15th April 2024

Abi Mark
Senior Environmental Planner, WBOPDC
1484 Cameron Road
Greerton, Tauranga 3112
Via email: abi.mark@westernbay.govt.nz

Response to Submissions, Further Mitigation Plan Change 95 – Pencarrow Estate Pongakawa

Date: 12.04.2024
 Drawing : 001
 Reference: Pencarrow Estate Pongakawa
 Scale: 1:2500 at A3
 Drawn: PT
 Reviewed: VM

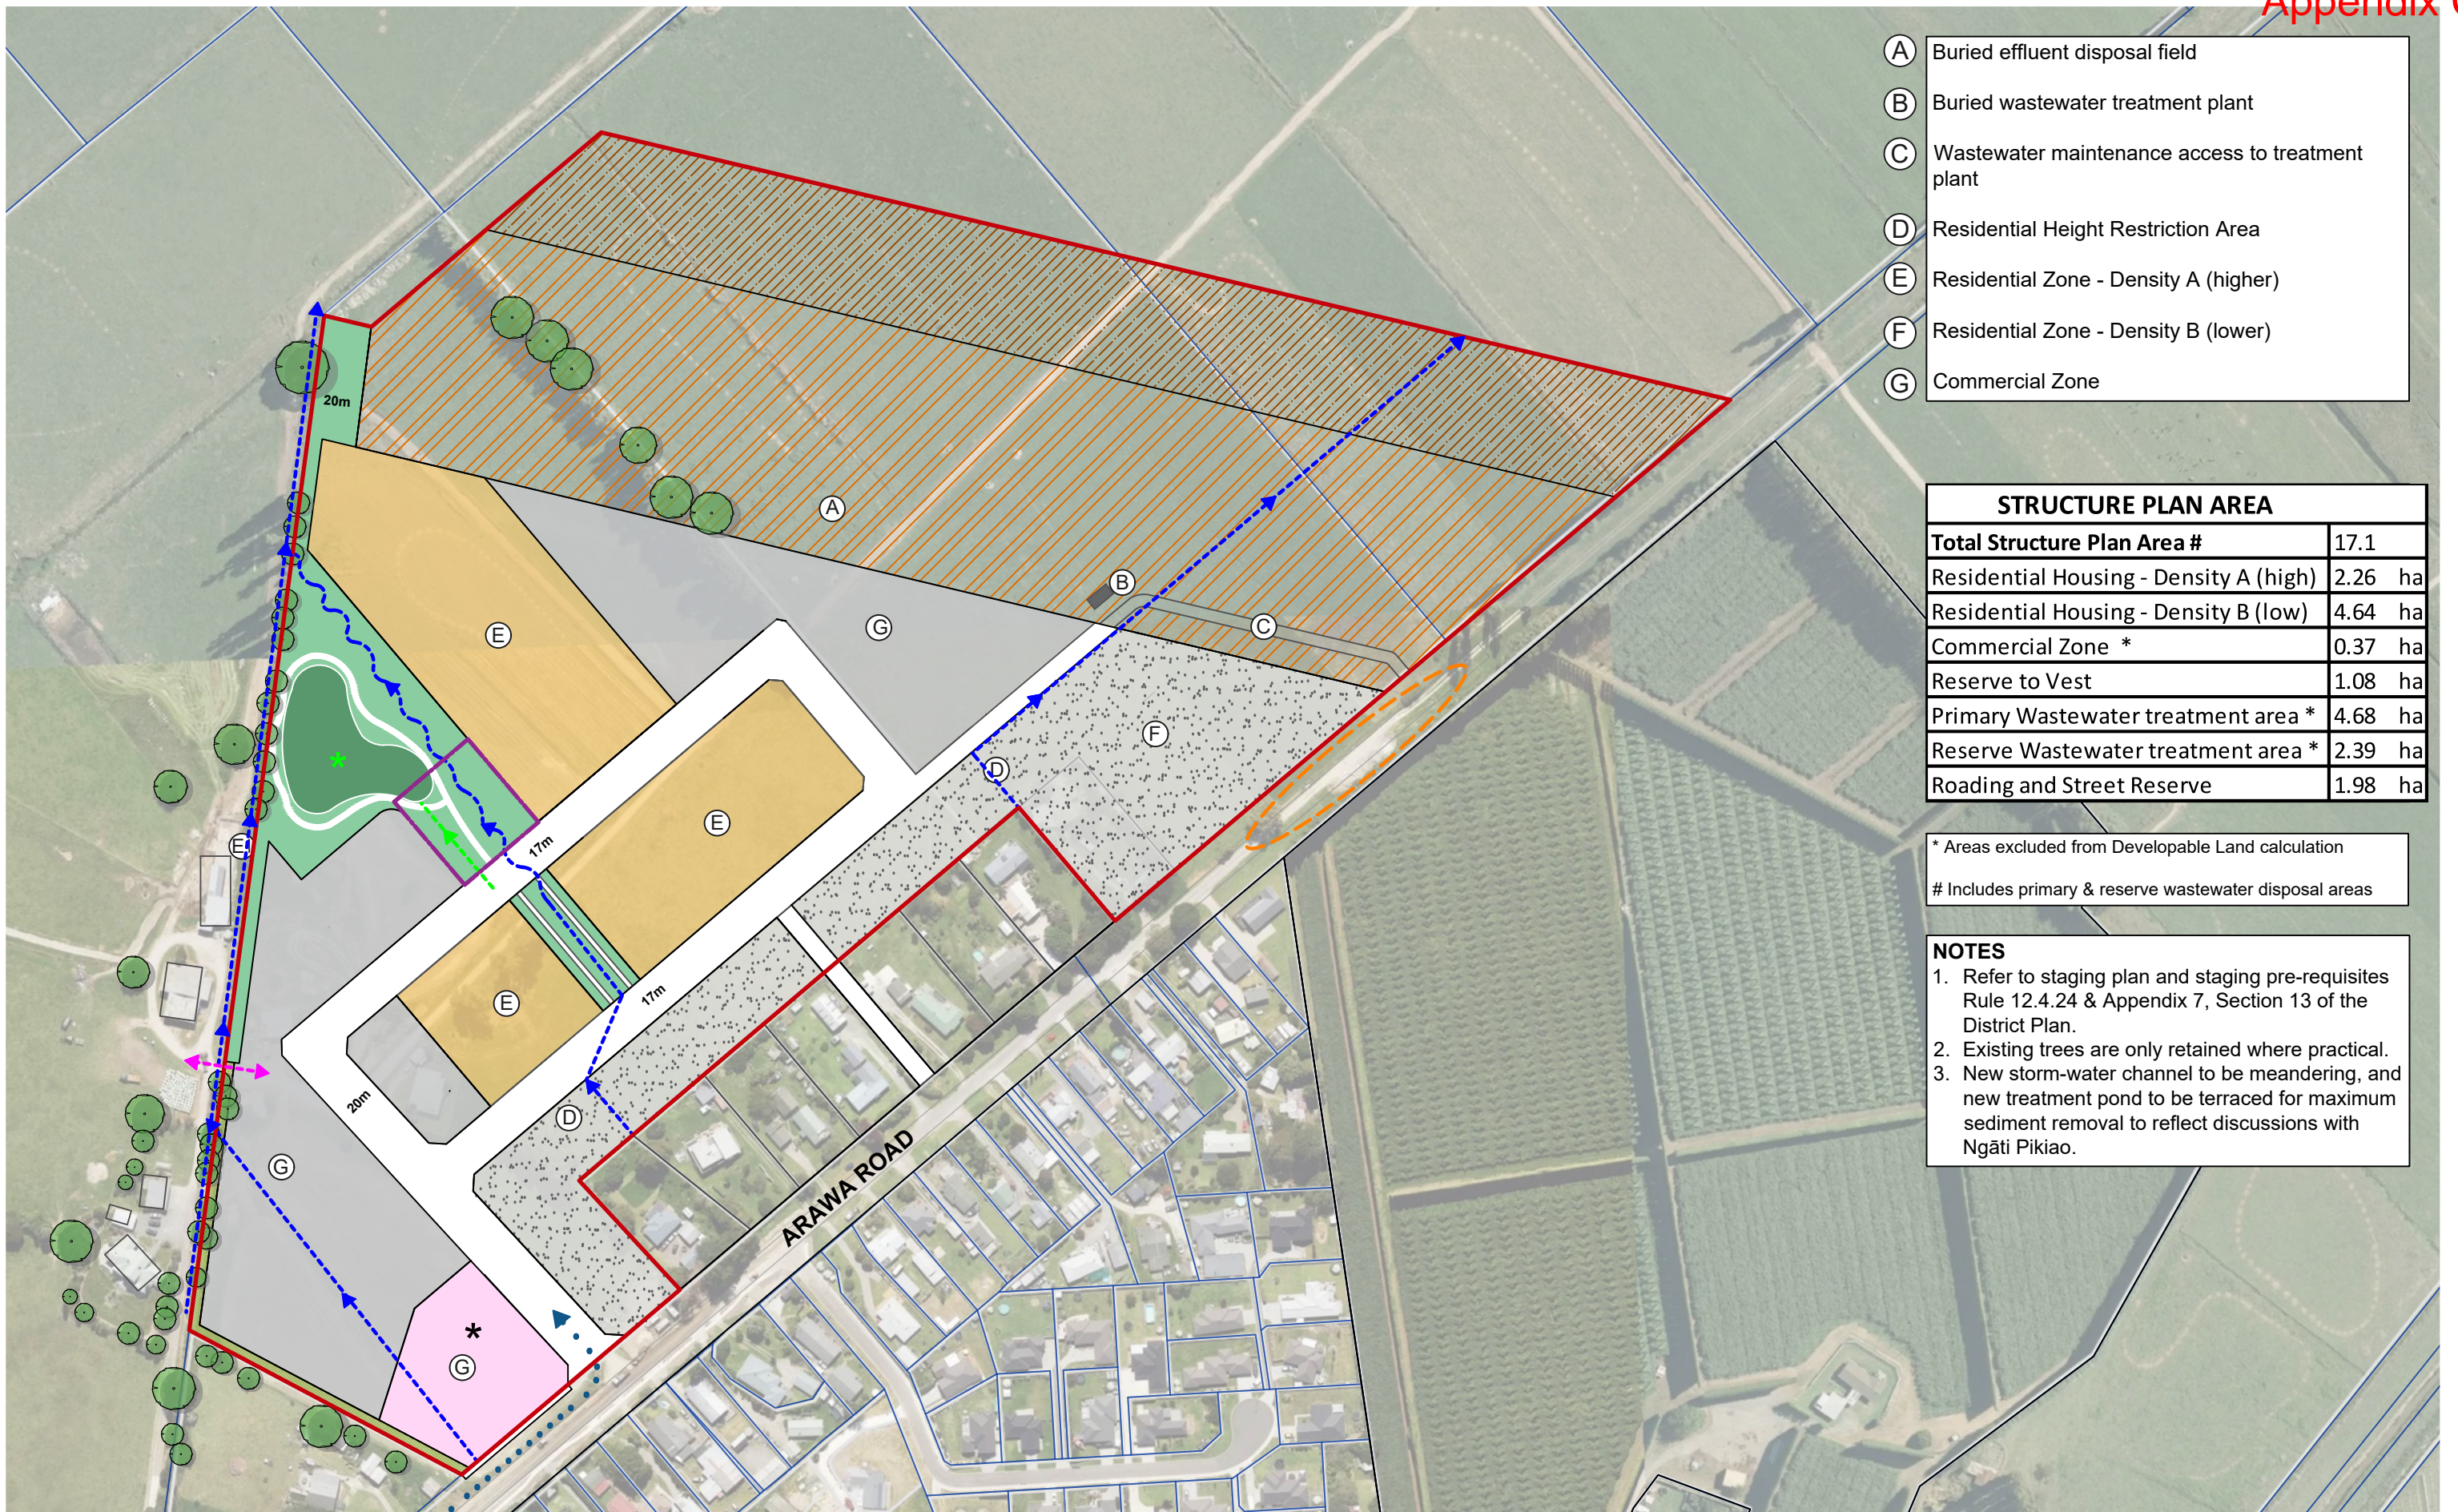
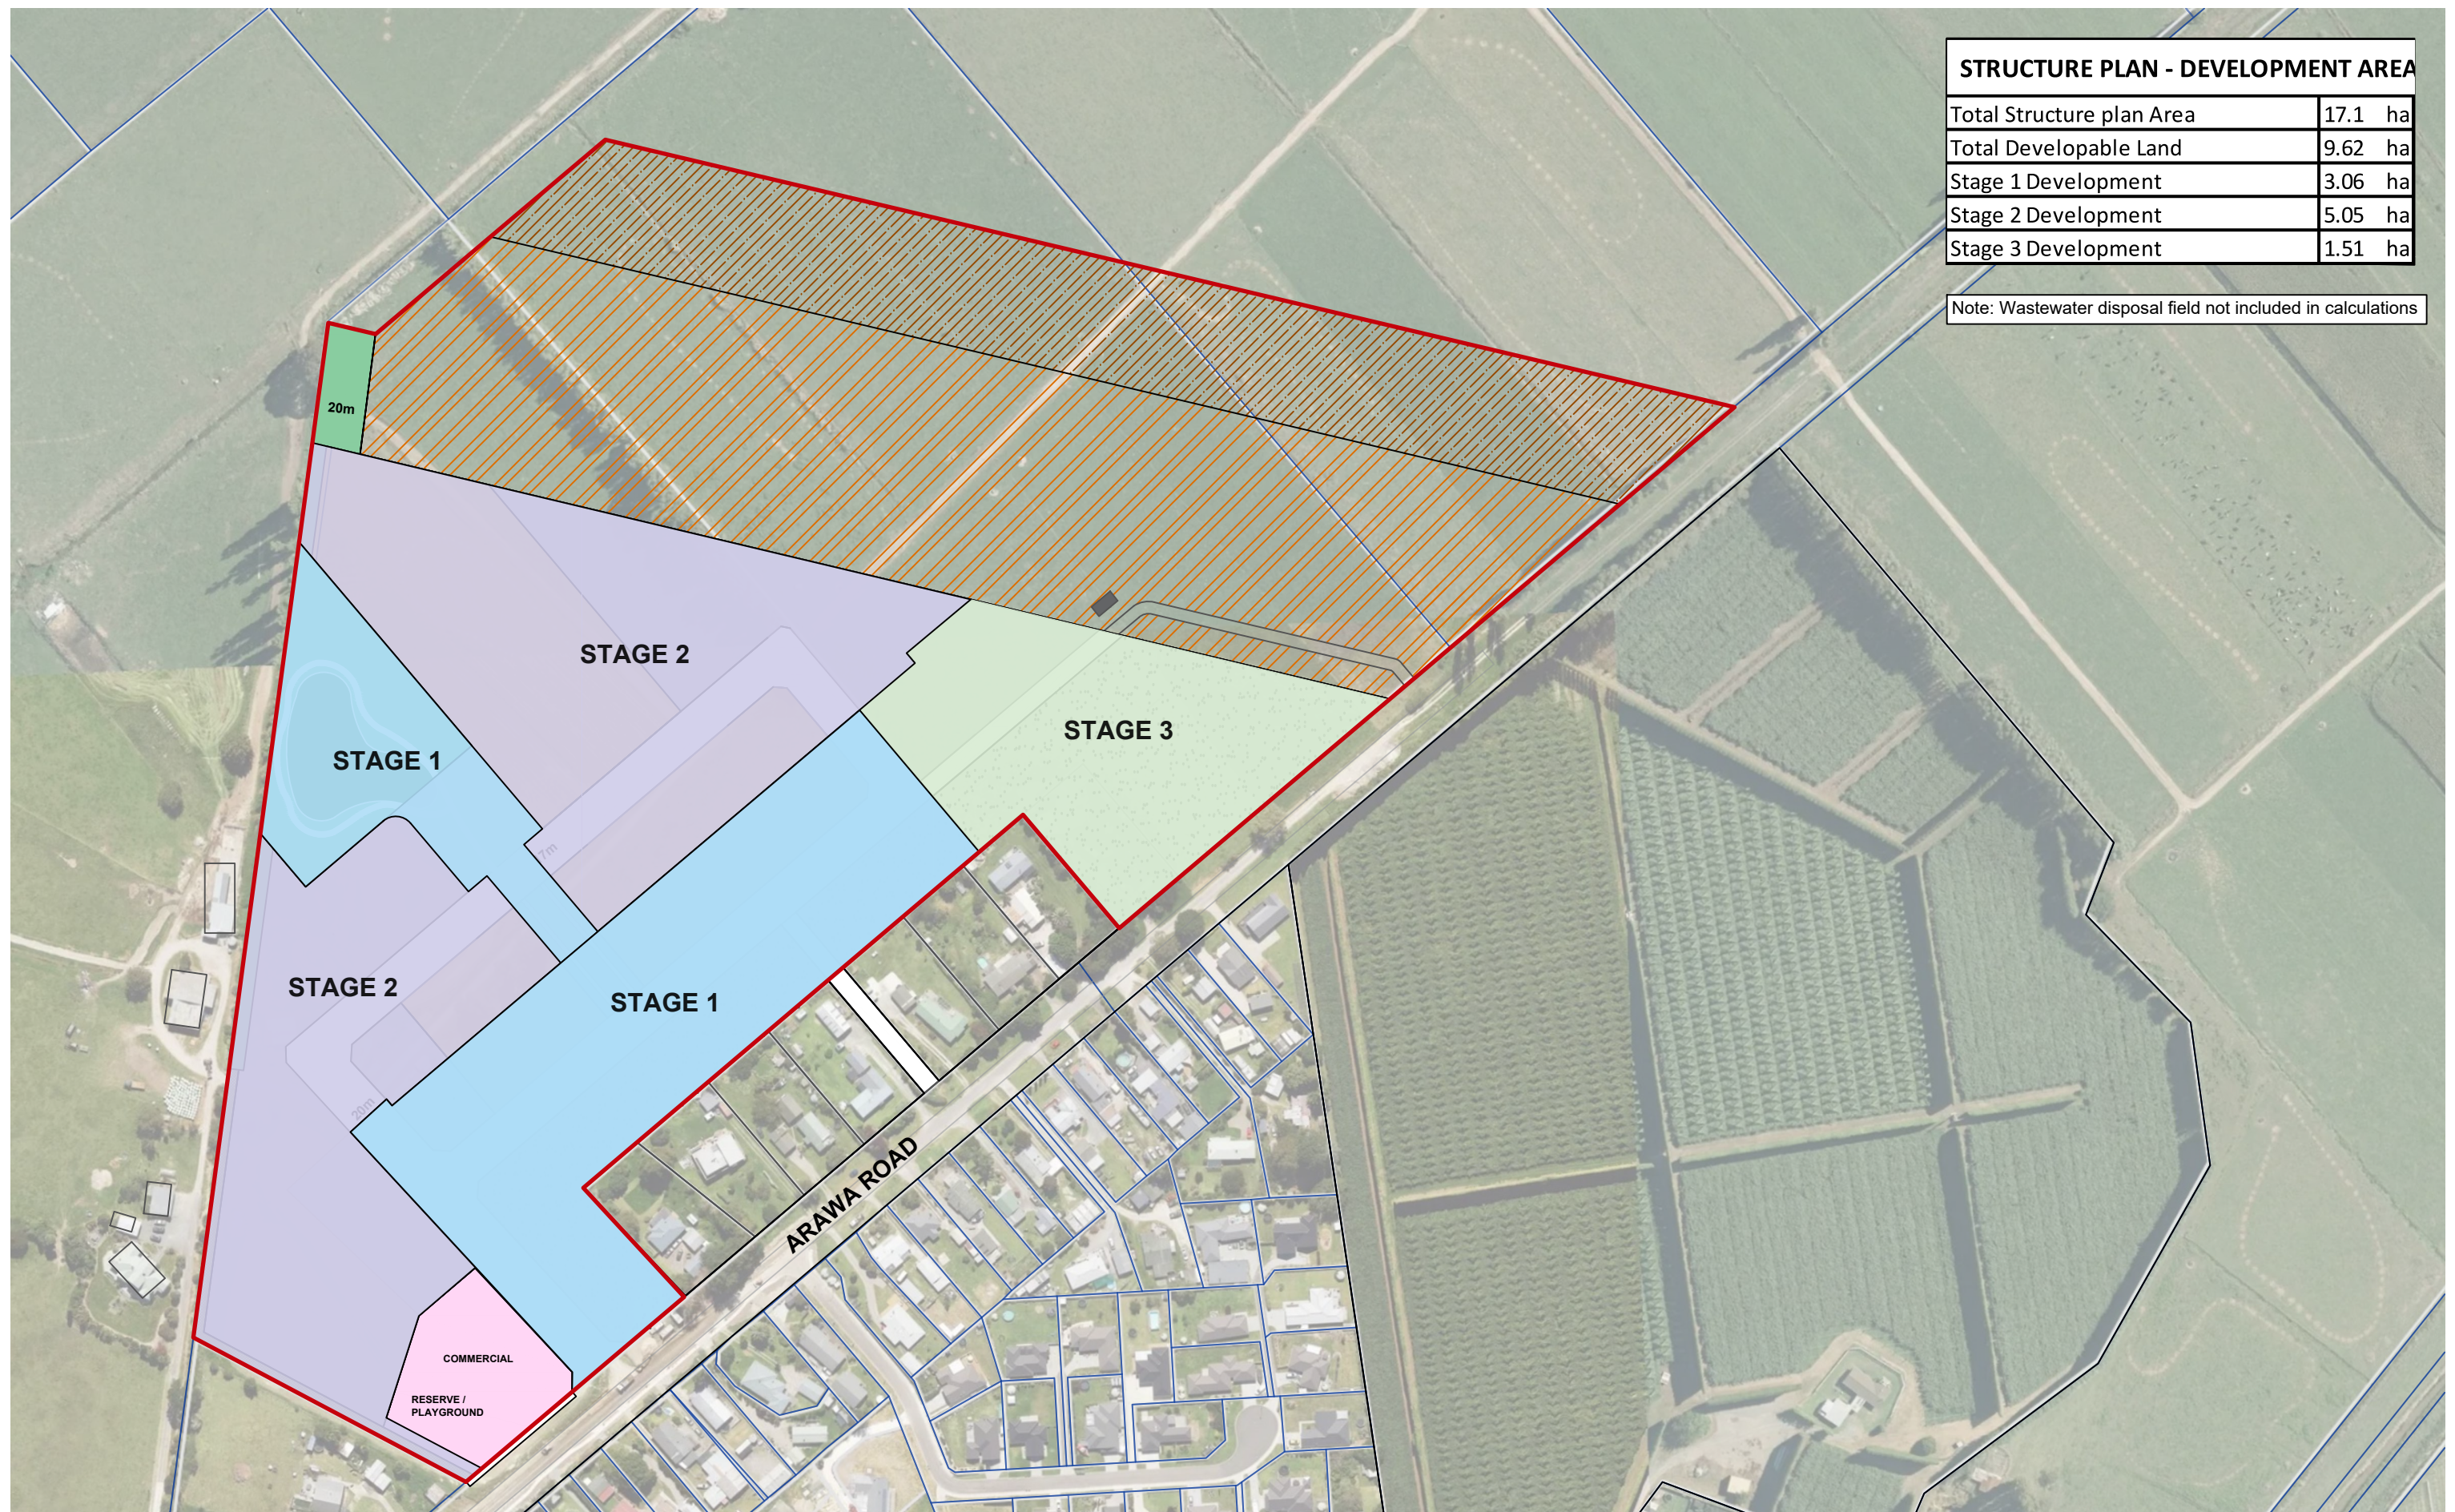
Numerous submissions discuss the general loss of rural character and amenity that accompanies urbanisation. This change is acknowledged, particularly in respect of Rural-zone properties on Arawa Road abutting the plan change site to the south-east. Adverse effects attached to this change have been sought to be reduced, by way of restricting the height and siting of future built form adjacent to eastern boundary of the site. Future building height adjacent to the eastern boundary is restricted to one storey.

Initially a set-back of 5m was applied to the eastern boundary of the plan change site, in combination with the height restriction. This being derived from considering the range of setback distances/boundary-constructed buildings along the rear boundary of Arawa Road properties. Noting concerns about outlook and spatial separation to future built form that have been raised in submissions, this setback has been increased to 8m. Trees have also been specified in this setback for greater natural elements within outlook towards the plan change area. This is reflected in revised proposed wording of rules to apply within Chapter 13 of the District Plan, see **Appendix B**, and revised structure plan drawings at **Appendix C**.
